CONVAIR  
A Division of General Dynamics Corporation  
San Diego, California

COMMERCIAL CHANGE PROPOSAL

SPEC NO: ZD-22-002

CUSTOMER: Hughes Tool Company

CONVAIR 880 52" SEAT - TWA

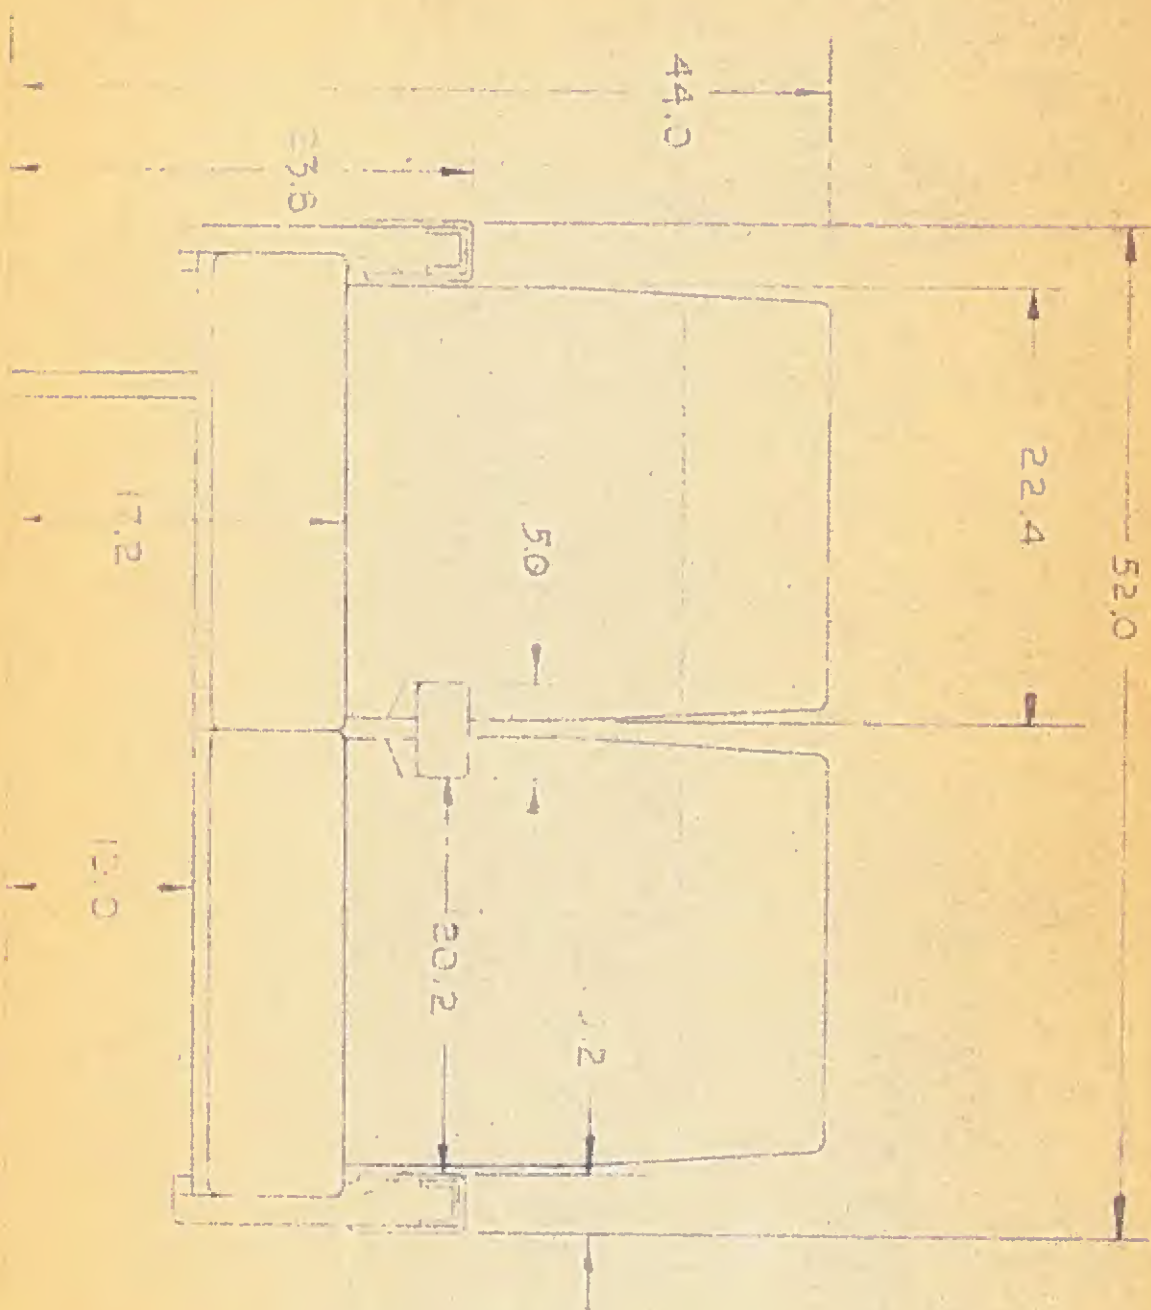
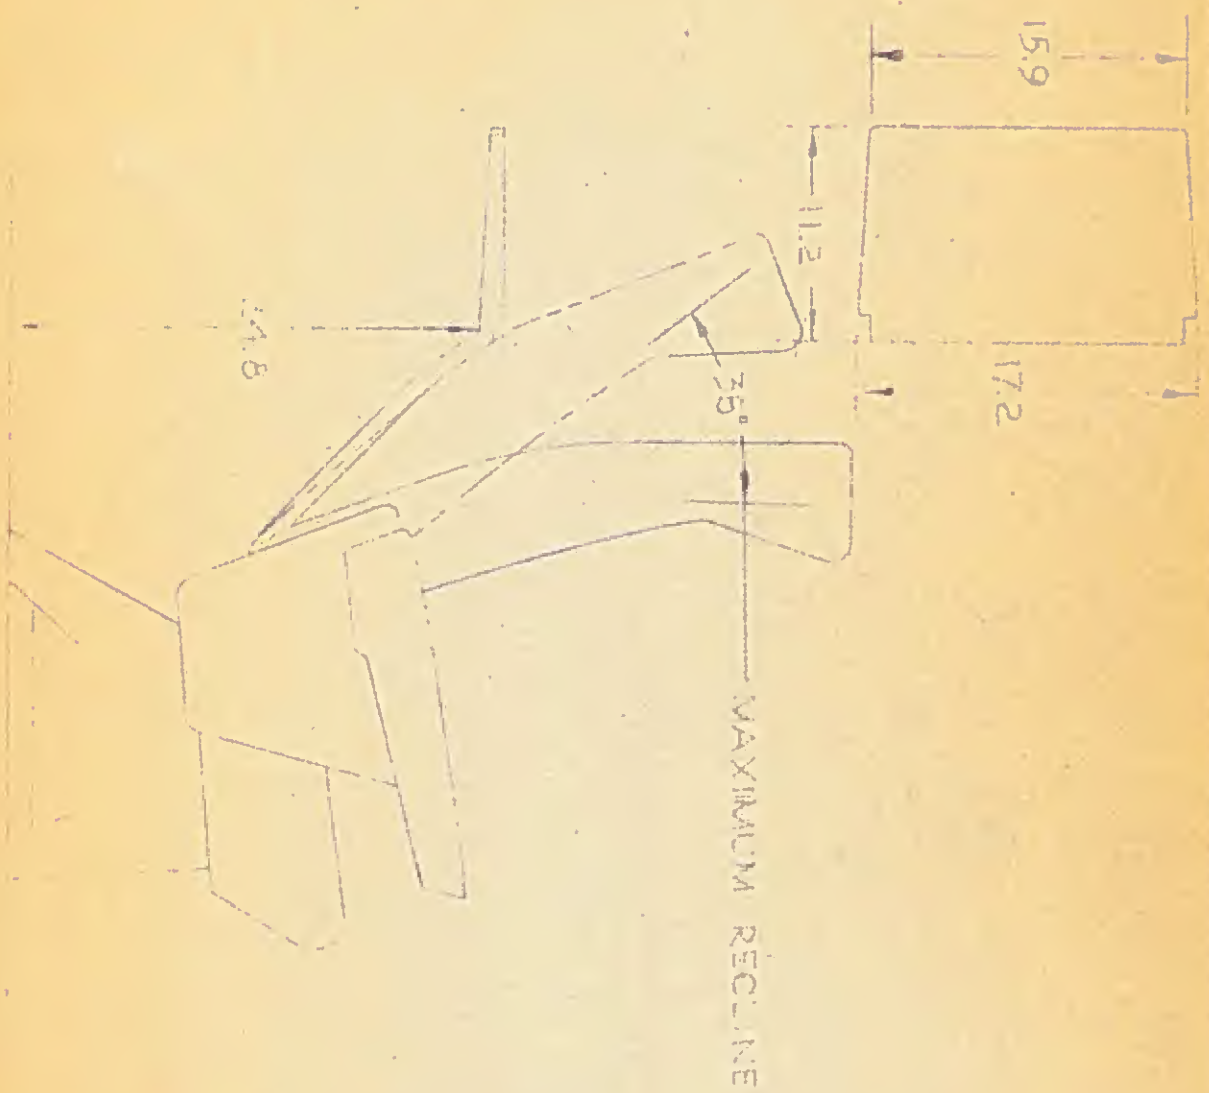
Page A-15, APPENDIX I-C, FURNISHINGS:

Change 22nd item as follows:

To: \*36 Double Passenger Seats (Including  
fabric and belt)

1,937 lb"

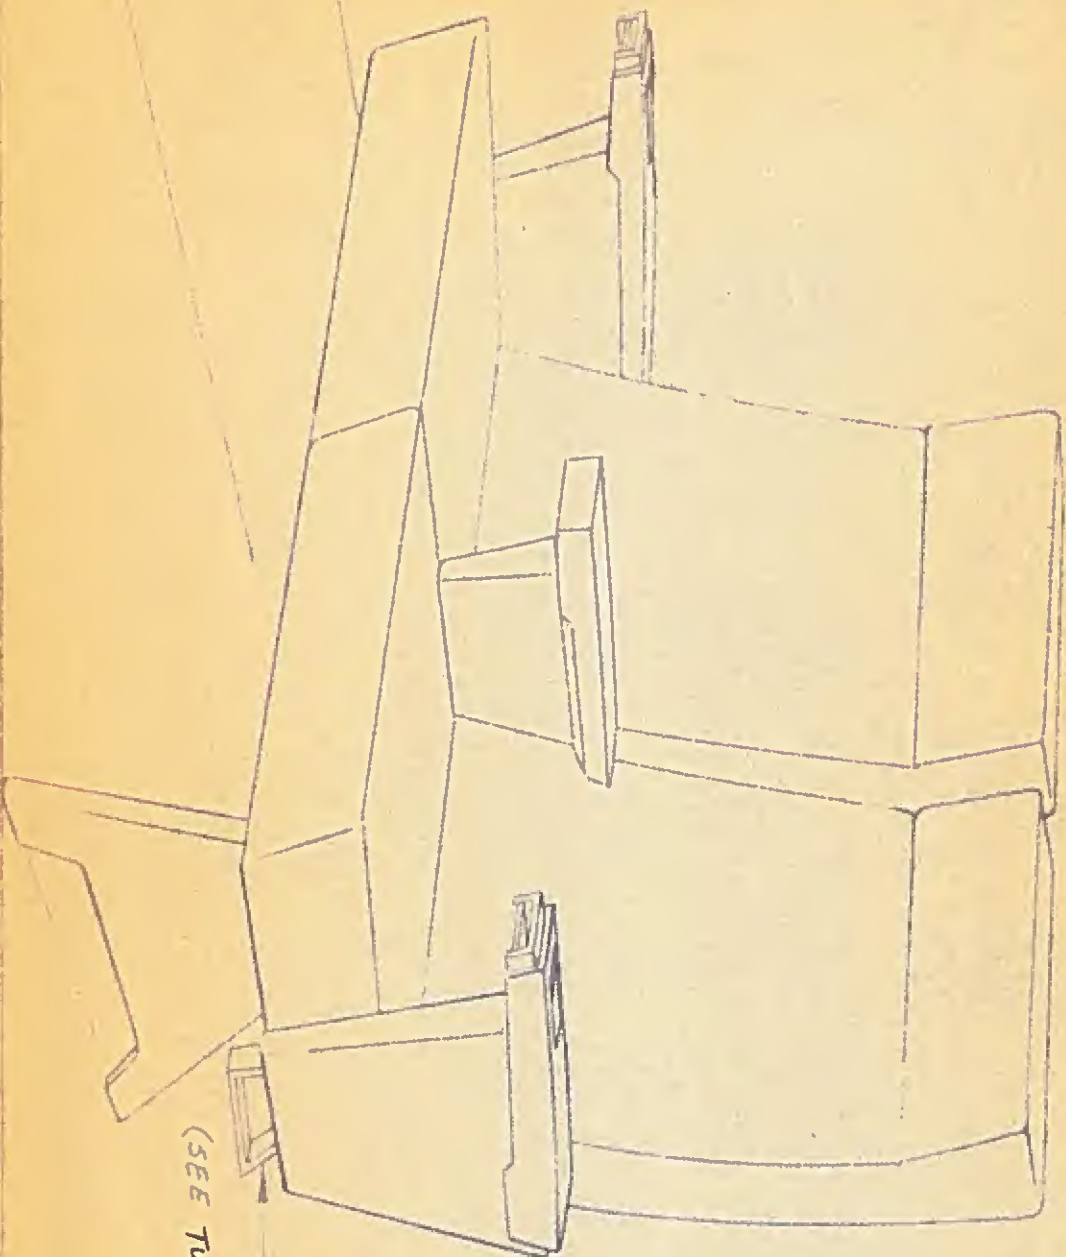
Page A-15, APPENDIX I-C, FURNISHINGS:

Change 22nd item as follows:

To: \*"36 Double Passenger Seats (Including  
fabric and belt)

1,944 lb"

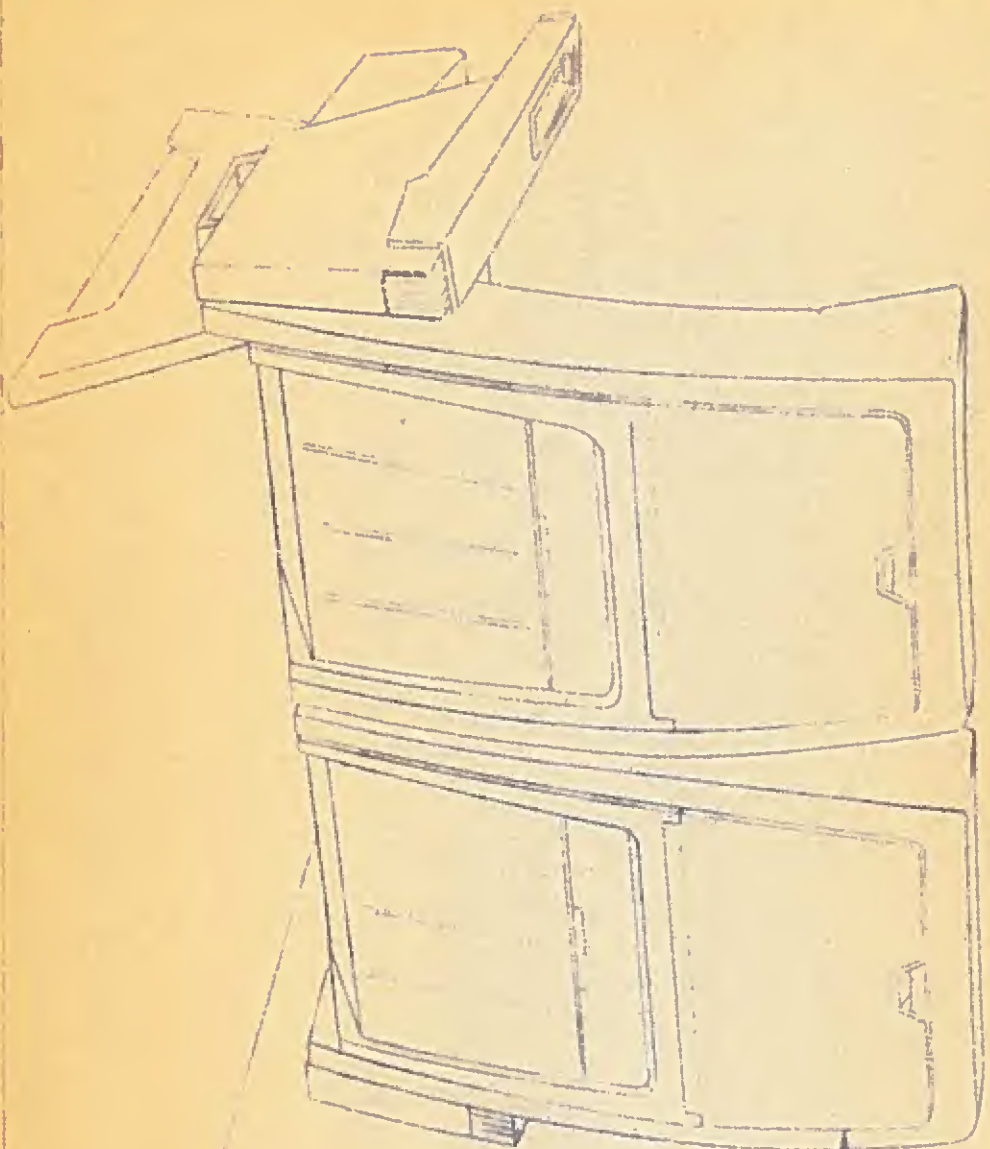
Page A-15, APPENDIX I-C, FURNISHINGS:

Change 22nd item as follows:

To: \*"36 Double Passenger Seats (Including  
fabric and belt)

1,969 lb"

FIGURE 3.19-4

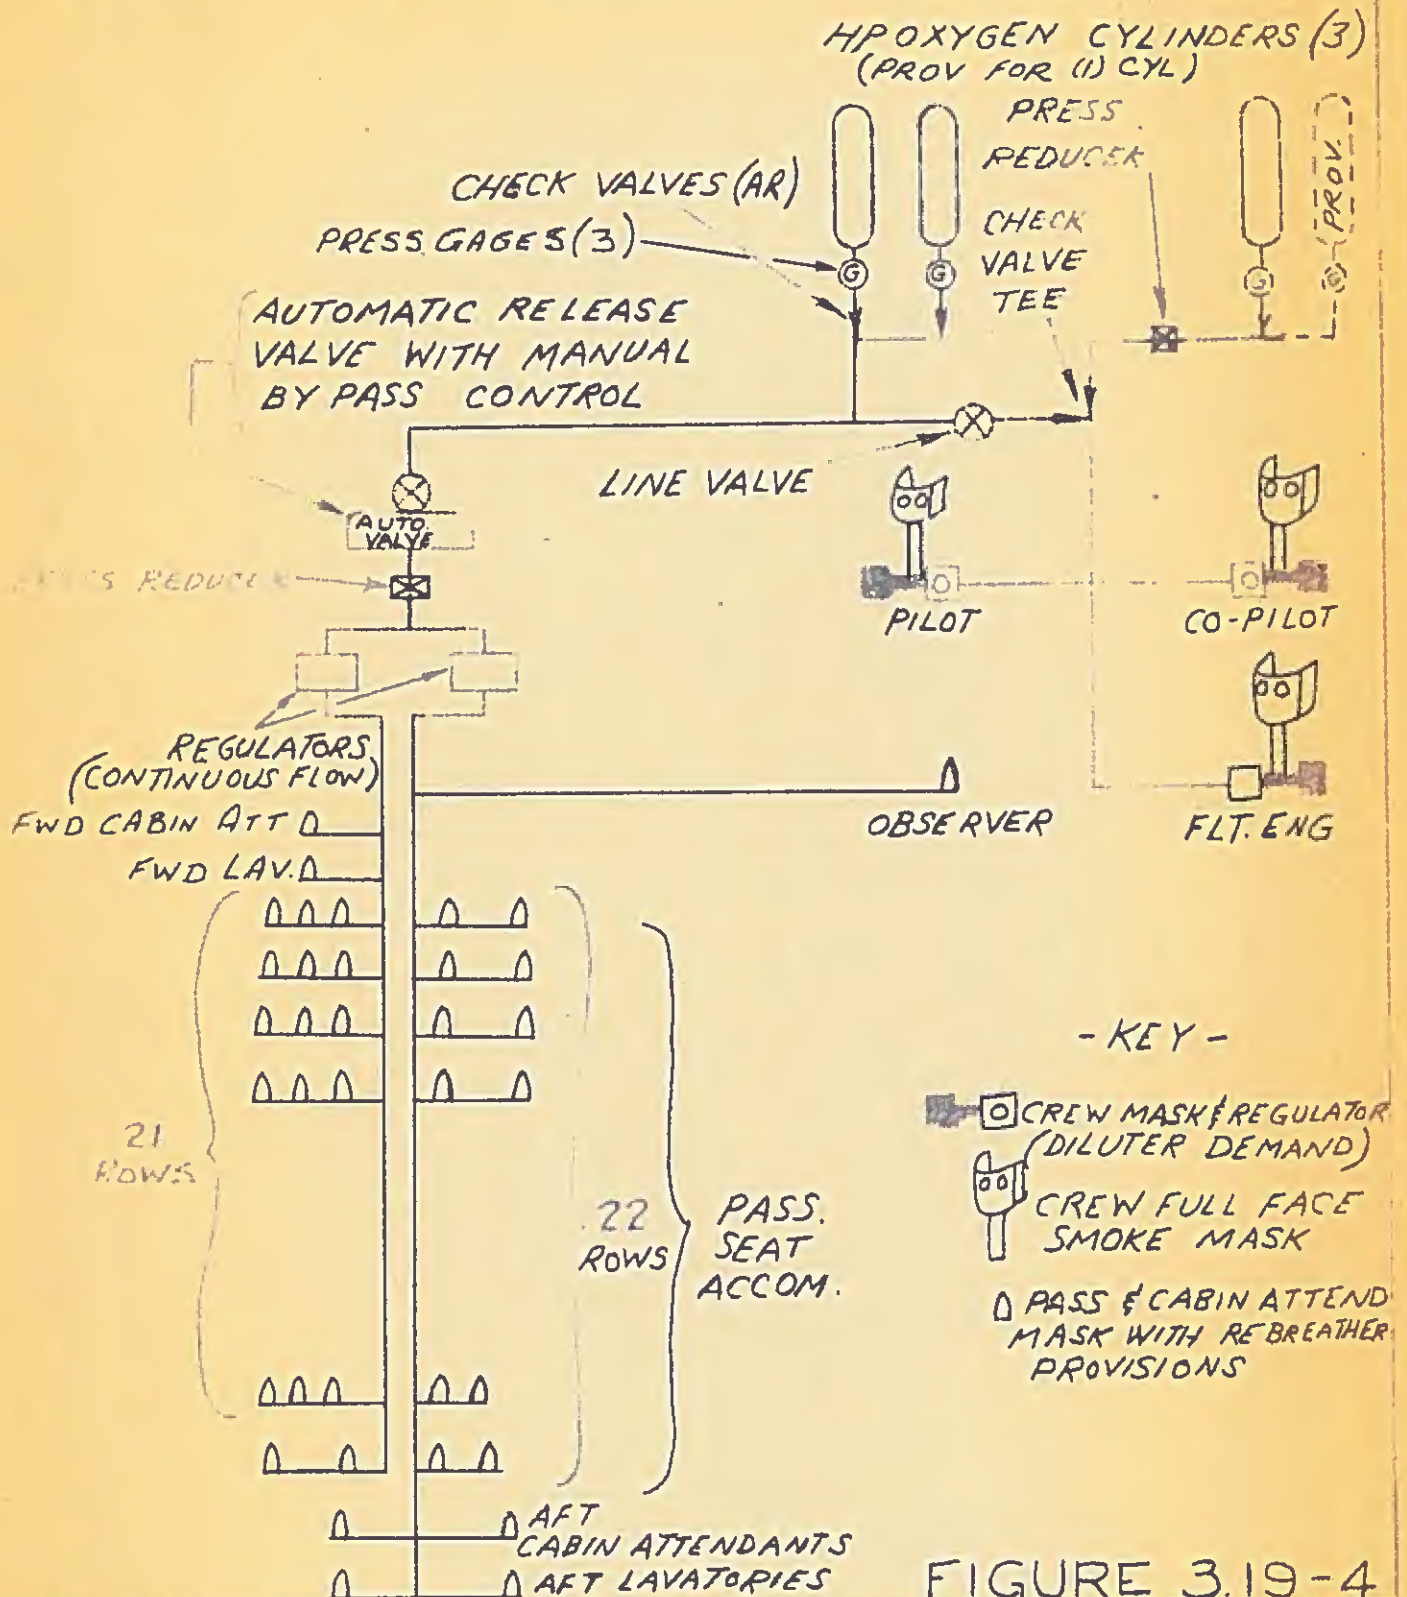
Figure 3.19-4 HIGH PRESSURE OXYGEN GAS SYSTEM SCHEMATIC

Enclosure: (A) Figure 3.19-4 HIGH PRESSURE OXYGEN GAS SYSTEM (Revised)

FIGURE 3.19-2  
(REV. 2-17-58)

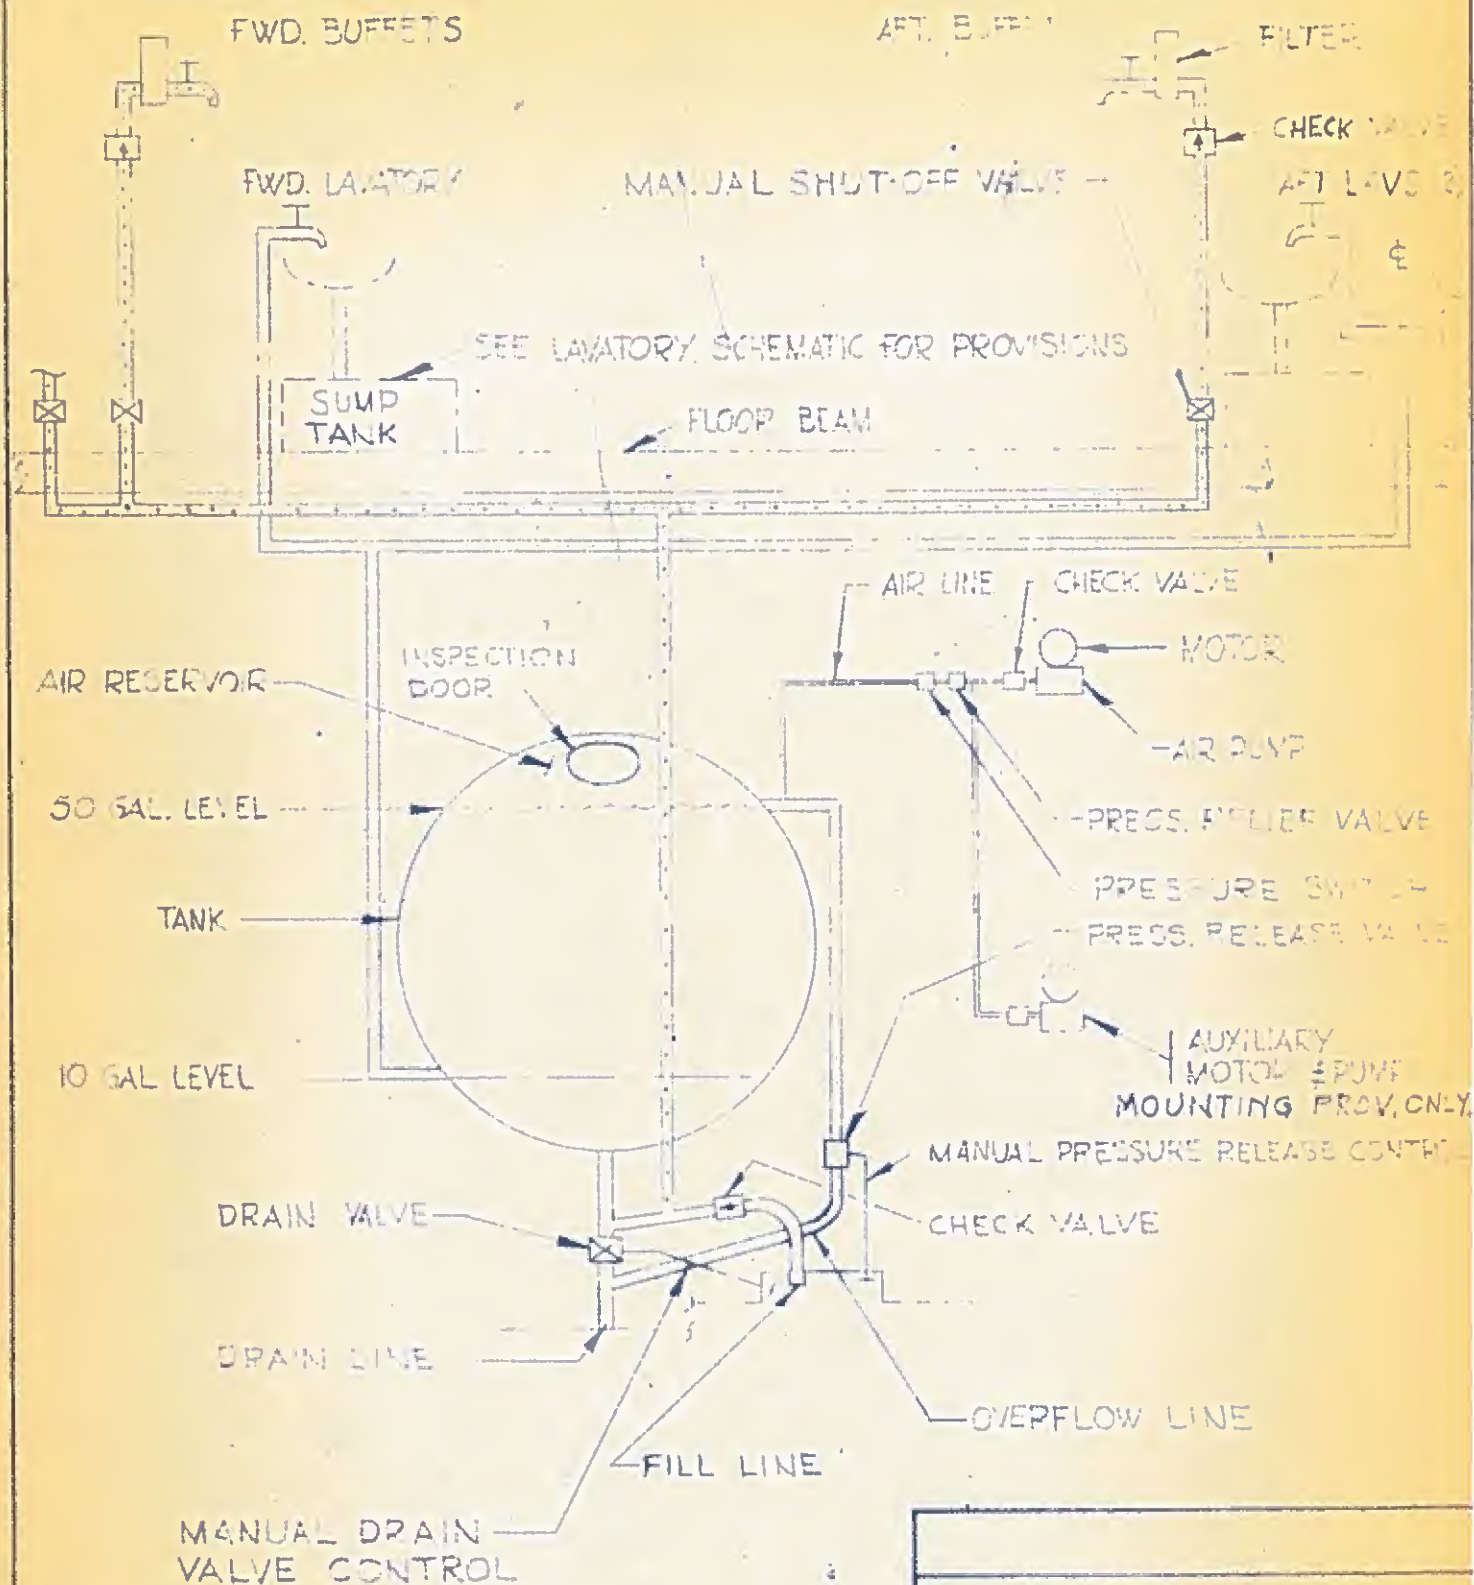
Figure 3.19-2 WATER SYSTEM SCHEMATIC:

Enclosure (A): One (1) copy of Figure 3.19-2 WATER SYSTEM SCHEMATIC  
(revised 2-17-58)

FIGURE 3.1-2

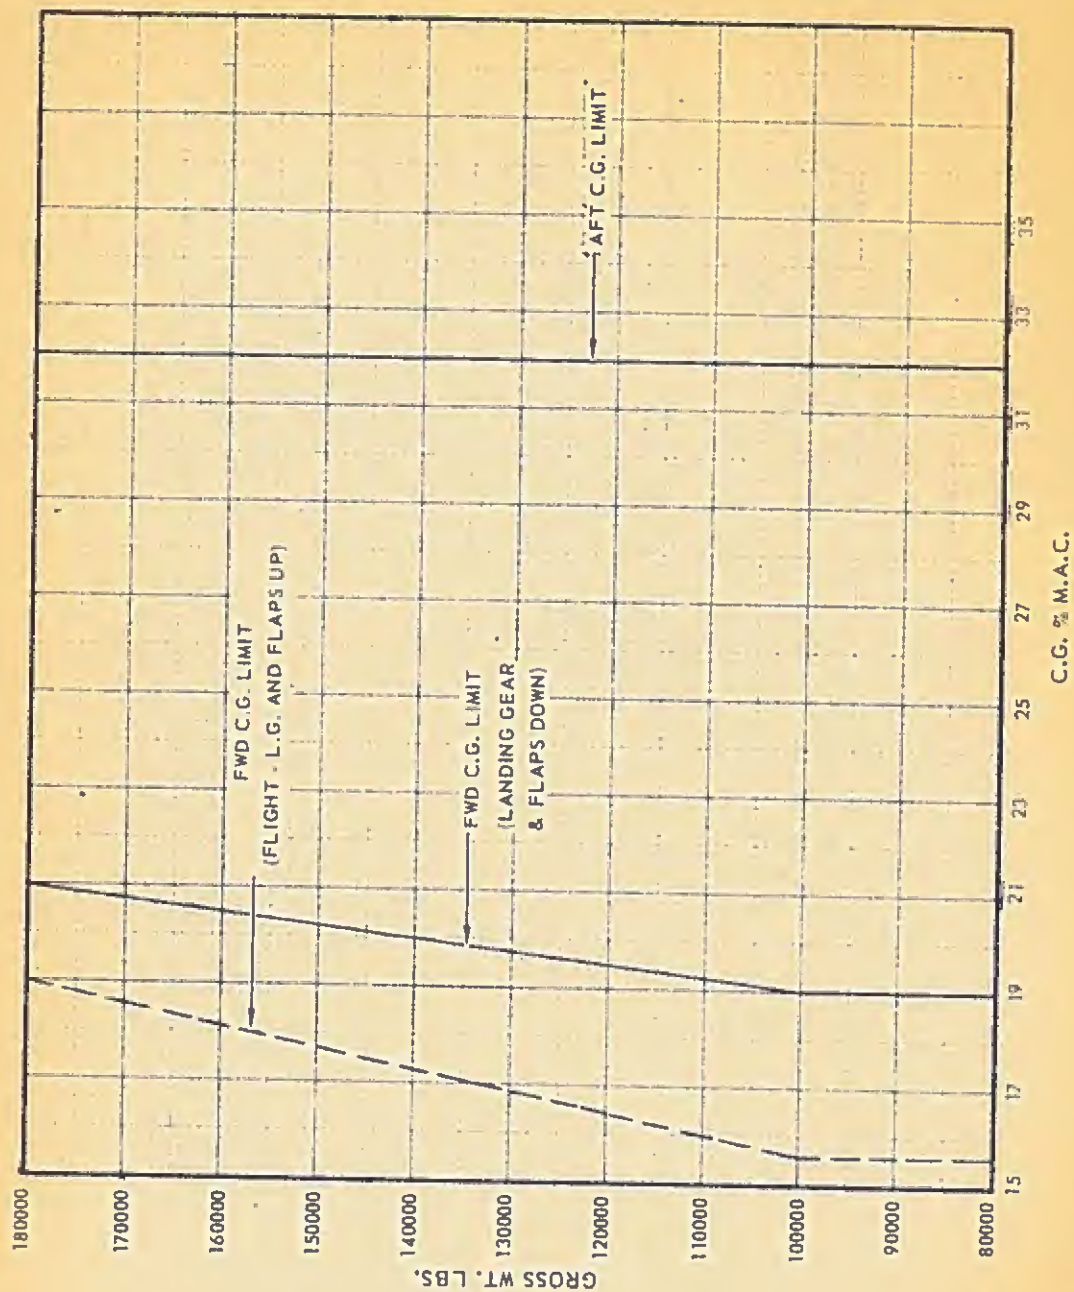
Figure 3.1-2 C.G. DESIGN LIMITS

Replace present figure in Specification with Enclosure (C)

Enclosure: (C) Four (4) copies Figure 3.1-2, C.G. DESIGN LIMITS
